SERVICE BULLETIN

Reference number:	SB-30-1497V4	Issued: 04 June, 2021
Subject:	Connector Repair Process for Weak GPS Signal	
Model(s):	DBX (up to VIN: V01738)	
Applicable to:	All Dealers	
Distribute to:	After Sales Manager Executive Manager Service Manager Sales Manager	Warranty Staff Technician(s) Parts Staff

Reason for this Service Bulletin

Figure 1

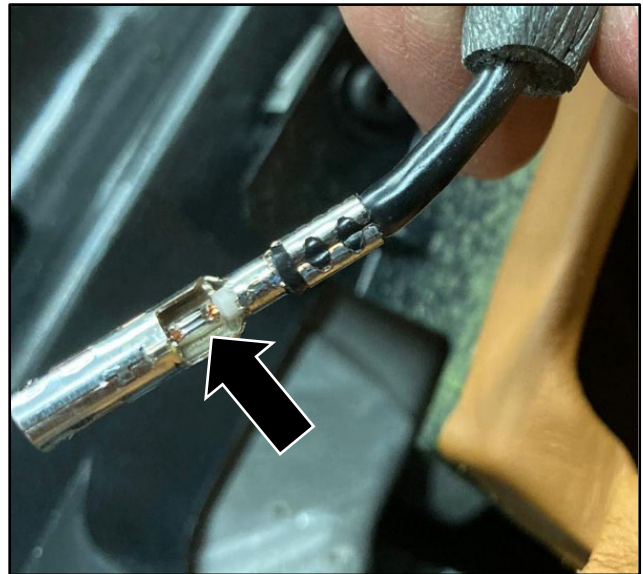
6. Remove the connector from the applicable connector housing (refer to Figure 4).

Note: This image shows a connector before any tape is applied.

Figure 2

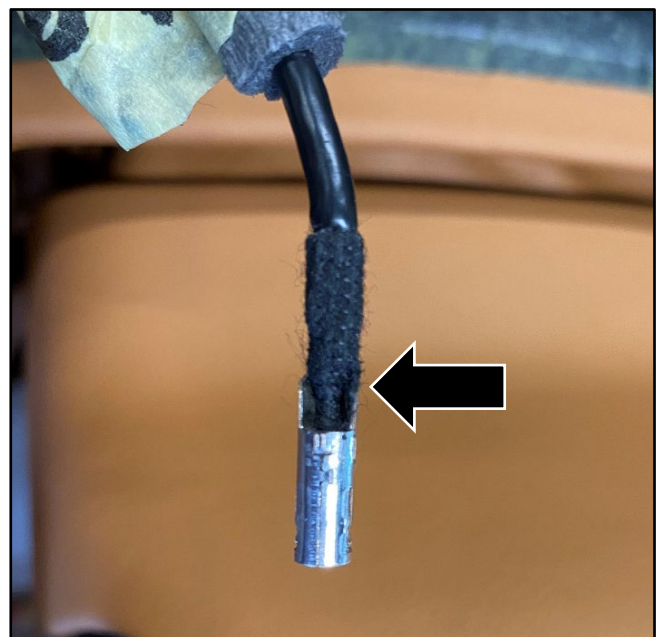
7. Apply harness repair tape to the area shown on the applicable cable.

Care must be taken not to damage the inner core and no gaps are shown (refer to Figure 5).

Note: The harness repair tape must be applied before the copper tape.

Figure 3

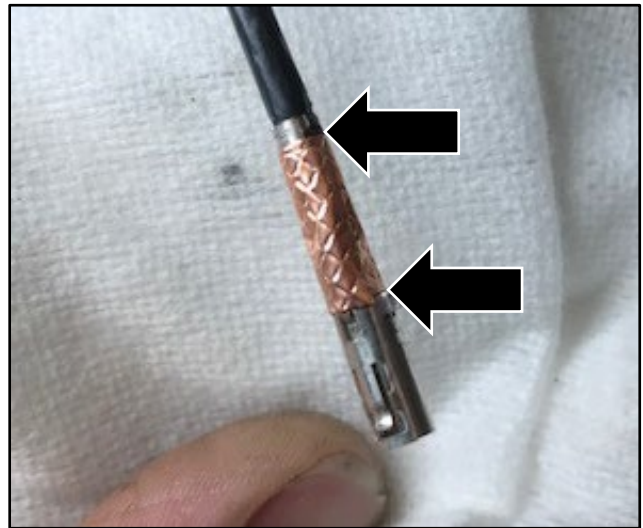
8. Apply copper tape to the area shown. You must make sure there are no gaps to the areas shown as this will cause electromagnetic interference (refer to Figure 6).

Note: Make sure the copper tape is applied tightly and neatly. Loose or untidy copper tape will prevent correct installation. It is possible that the loose copper tape will be compressed by the connector and cause the repair to not correct the problem.

Figure 4

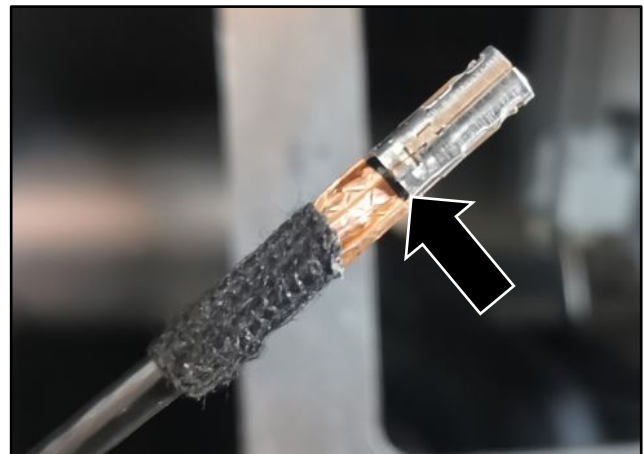
9. This image shows copper tape, that has ***not*** been applied correctly (refer to Figure 7).

Note: The gap shown will allow electromagnetic interference and cause the repair to not correct the problem.

Figure 5

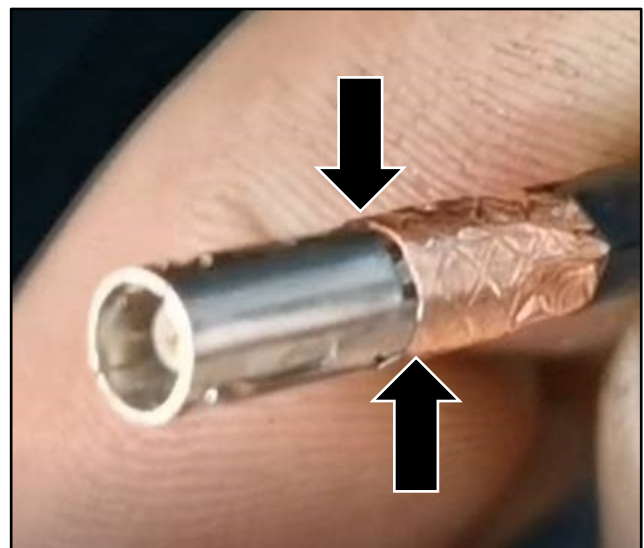
10. This image shows copper tape, that has been applied correctly (refer to Figure 8).

Figure 6

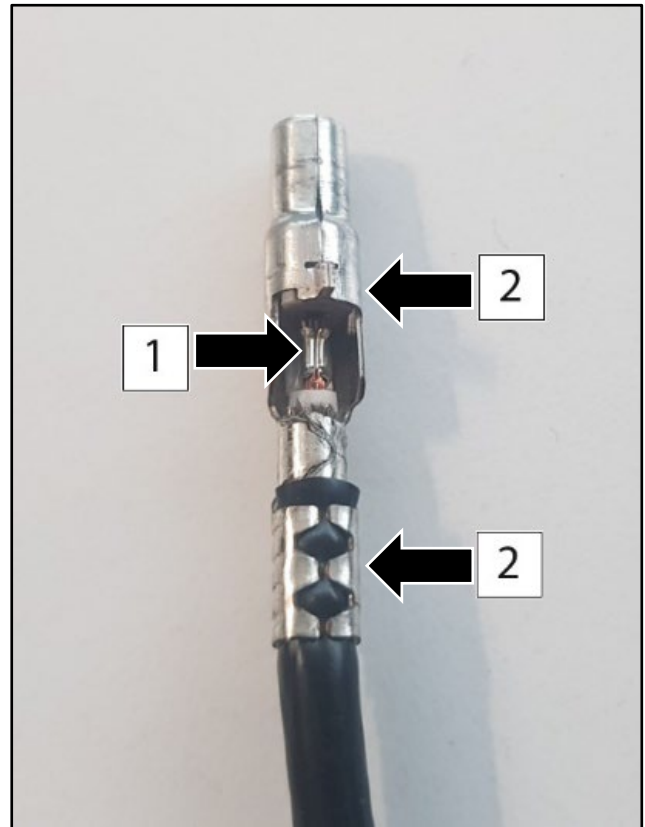
- 11. Make sure the inner part of the connector (1) is isolated from the outer part of the connector (2) when you apply the copper tape (refer to Figure 9).

CAUTION: DO NOT CAUSE A CONNECTION BETWEEN THE INNER AND OUTER PART OF THE CONNECTOR WHEN YOU APPLY THE COPPER TAPE. IF THE TWO PARTS OF THE CONNECTOR ARE IN CONTACT, THE CONNECTOR WILL NOT FUNCTION CORRECTLY.
